**Re:** BusConnects Bray to City Centre Core Bus Corridor Scheme  
Bray to Dublin City Centre.

**RE: SUBMISSION TO AN BORD PLEANALA IN RESPECT OF SECTION 51(2) APPLICATION BY THE NATIONAL TRANSPORT AUTHORITY FOR THE CONSTRUCTION OF THE BRAY TO CITY CENTRE CORE BUS CORRIDOR SCHEME**

**Bord Pleanála Case Reference: HA27.317742**

## Silvicultural Assessment of CPO on Beauchamp House

**Figure 2: Extract from General Arrangement Sheet 50 (Approximate site boundary outlined in navy). Source: NTA, 2023.**

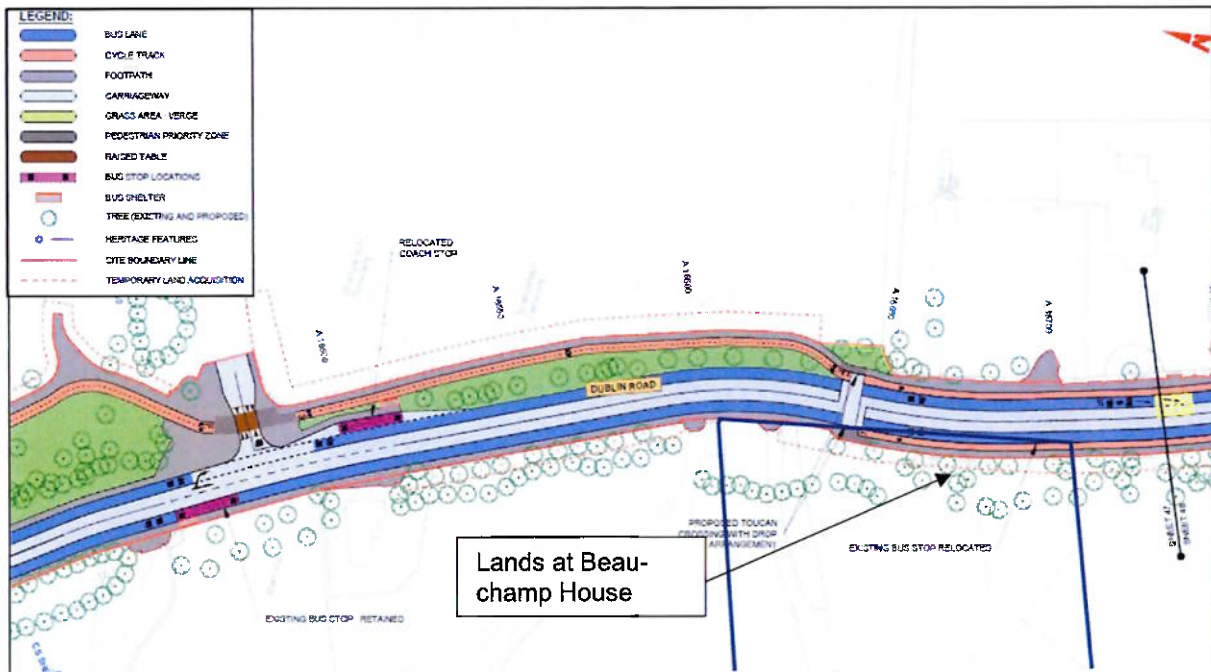
Extracts of the 'General Arrangement Drawings' Sheet 50 (Figure 2 above) set out high level details of the route proximate to Beauchamp House and associated lands. The alignment of

The proposed land take to accommodate a bus and cycle lane on the west side of the Dublin Road will directly impact on the 19th century coursed granite rubble demesne wall

(CBC0013BTH030) with bevelled granite cap to Beauchamp House (NIAH Ref.: 60260168, DLR RPS Ref.: 1862), necessitating its removal and construction of a replacement boundary wall. It is said to be of *'Medium Sensitivity'*. A number of trees along the boundary will be removed. The magnitude of impact is noted as *'Medium'*. The potential Construction Phase impact will be *'Direct, Negative, Moderate and Temporary'*.

**Figure 4: Extracts from Sheet 6 and Sheet 7 of Lands to be Compulsorily Acquired Deposit Map (approximate site boundary shown in blue). Source: NTA, 2023.**

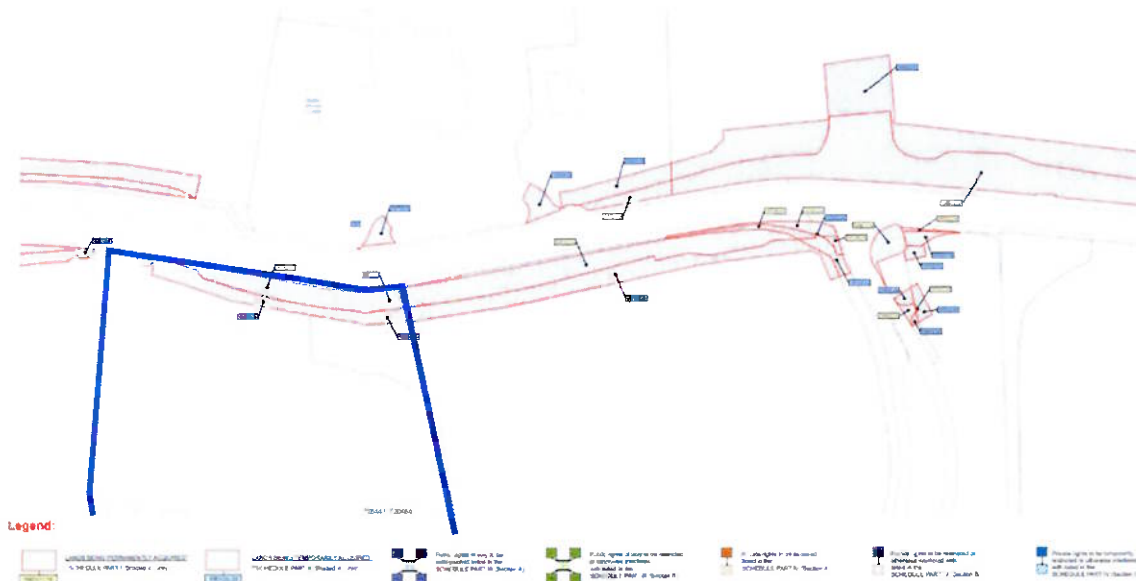
Temporary and permanent land acquisition is identified for Beauchamp House and visible by the redlines in Figure 4 below.

Figure 5: Extract from Tree Removal Plan (approximate site boundary shown in blue). Source: NTA, 2023.

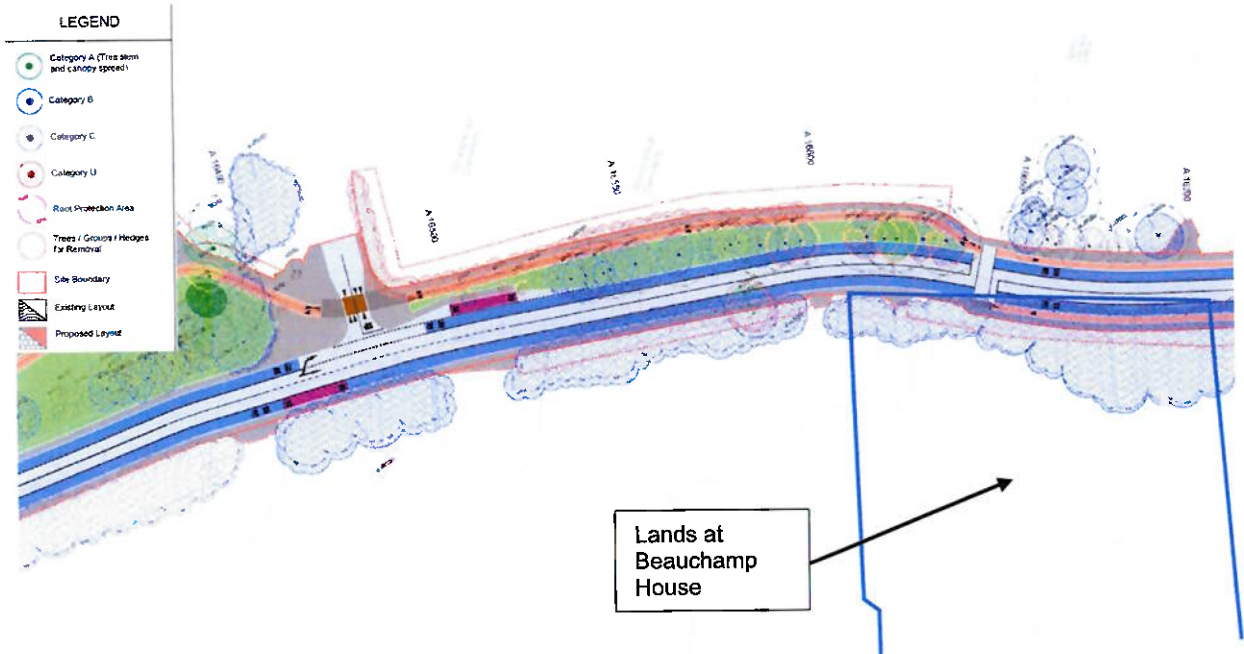
Application). We have included extracts from Tree Removal Plan (see Figure 5) with tree /hedges to be removed highlighted by solid redline. The tree removal plan shows that part of a tree group along the road frontage of the property are to be removed.

It is unclear how many trees along the front boundary of the property are proposed to be removed. While it is noted that a ‘Tree Removal Plan’ has been submitted, the trees on our clients’ lands have not been individually surveyed, instead they have been classed as a tree ‘Group’. The submission sets out the following in relation to recommendations regarding tree removal on the site “*Remove c.1911m<sup>2</sup> to facilitate proposal and replace as good arboricultural practice*”. Only 7 no. trees are being proposed to replace the partial loss of a significant group of trees, which includes a number of mature trees. This is not considered to be an adequate

Figure 6: Extract from Landscaping Proposals Sheet 50 (approximate site boundary shown in blue). Source: NTA, 2023.

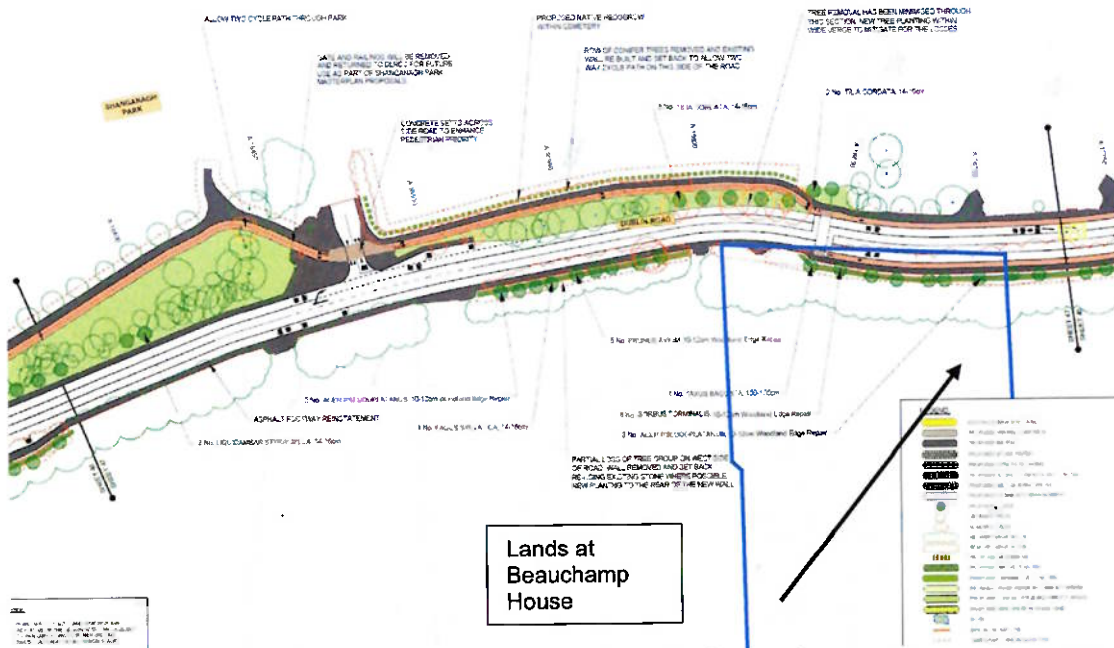
The landscaping drawings details sets out trees proposed to be removed along the boundary with Beauchamp House. Annotation on the drawing states that *'partial loss of tree group on west side of road. Wall removed and set back re-using existing stone where possible. New planting to the rear of the new wall'*

Figures 6 illustrates the extent of landscaping proposals with the consequent loss of trees also identified.

Figure 8: Extract from Figure 17.2 showing location of photomontages (Source: NTA, 2023).

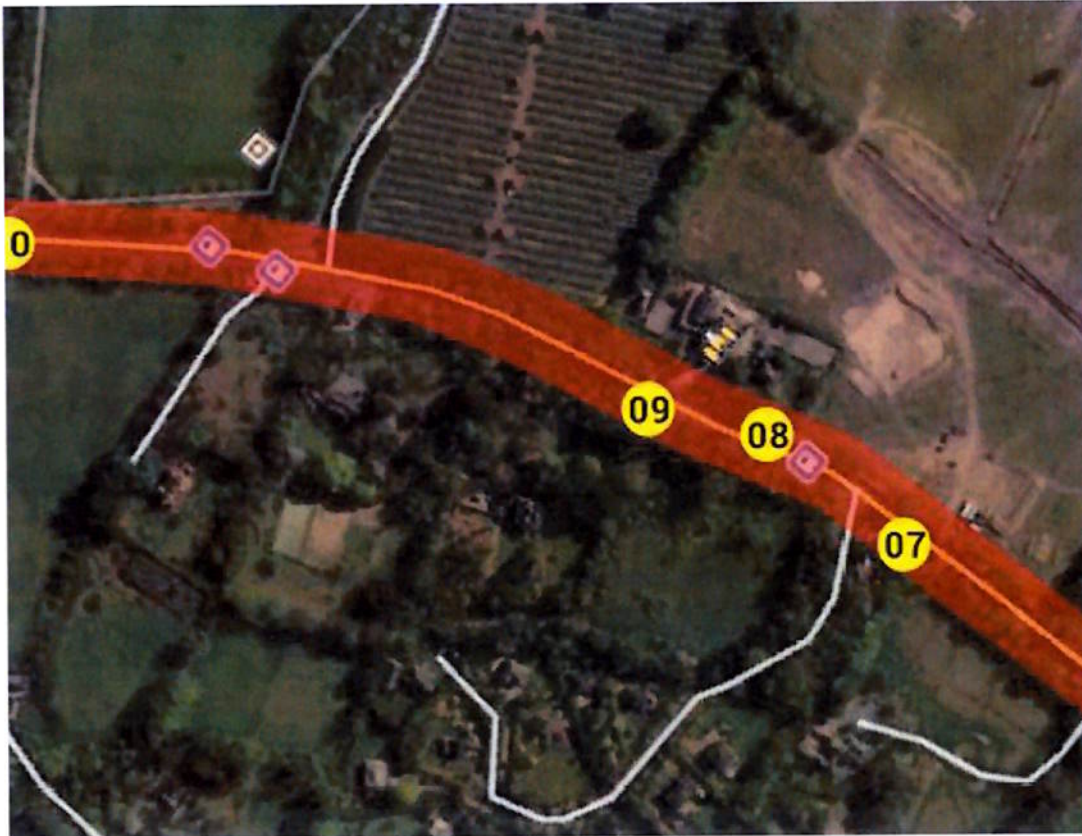
The application contains a series of photomontages detailing ‘before and after’ imagery. In particular Views 08 and 09 are of direct relevance to the Beauchamp House. Each view looks north towards Shankill from the Dublin Road.

Further, it is not clear if the planting shown in the views will appear as visualised or over a certain time i.e. after a 10-year period. Therefore, we respectfully request that further

information is submit by the applicant regarding this point. It is suggested that the photomontages of the streetscape provide a time lapse showing the planting over a number of years i.e. Year 1, Year 5 and Year 10, so that the short and medium term impacts can be properly assessed.

Figure 1: Extract from General Arrangement Sheet 50 (Source: NTA, 2023) red boxes highlight alterations from previous scheme.

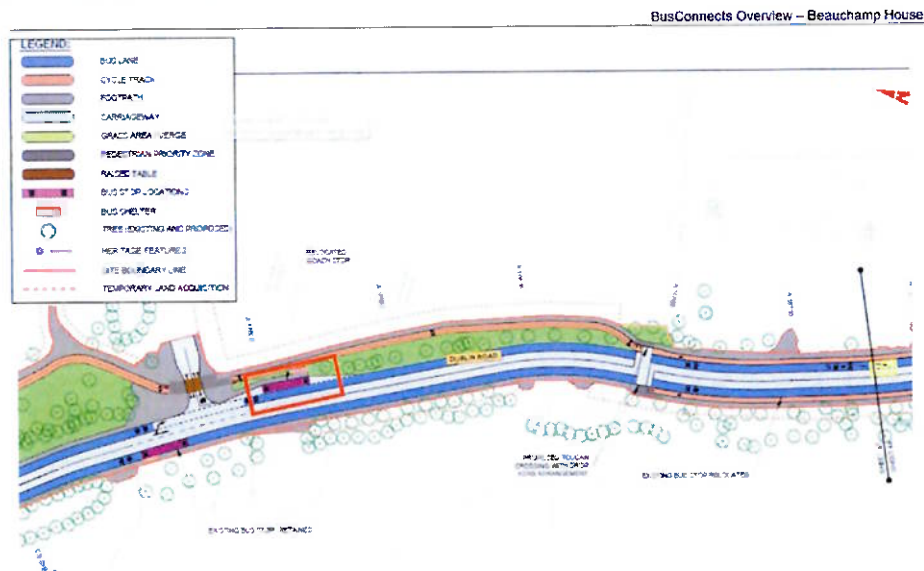
Figure 1 above gives the impression only 6 or 7 trees will be affected by the proposed works. This is very misleading. The impacted area is a long-established woodland, possibly ancient, which has evolved to be so much more than the sum of all its parts. It is a thriving, self-sustaining, naturally regenerating woodland, with very well-developed species, age, height, and habitat diversity. This woodland would not survive the removal of its entire eastern boundary.

The impact of any tree removal at Beauchamp House would go well beyond the small area marked in red and its 6 or 7 trees. Removing the entire eastern boundary would affect hundreds of stems, each an individual tree. Over 70 trees were recorded with diameters over 15cm dbh (diameter breast height), but it is important to note that many of the species
